Council Ref: OA2021/0009

Subject: Request for Comments - State Significant Development (SSD)
Application No: SSD-17899480
Property: 23-27 Lytton Street WENTWORTHVILLE NSW 2145,
Proposal: Redevelopment of Wentworthville Northside West Clinic, including demolition of a two-storey west wing building and southern car park, tree removal and construction and operation of a four-storey extension, alterations and additions to the Stage 1 building, landscaping and new car parking

Figure 4 - Post-development Model

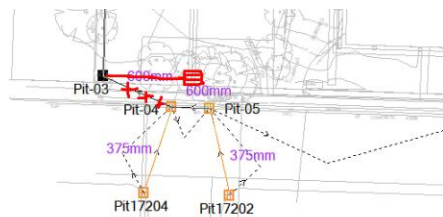
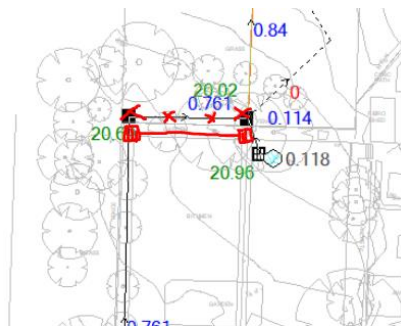
3. The proposed works will interfere with the existing sewer pits and sewer mains. The following matters need to be resolved prior to the determination of this application.
 - a) Separate approval shall be obtained for the storm water deviation design and construction works. Proposed realignment shall be located within the subject site. In this regard design may need to be modified during the above stormwater approval as follows:

- b) No building or structures are permitted over the Council's stormwater pipe and/or associated easements. This has not been demonstrated.
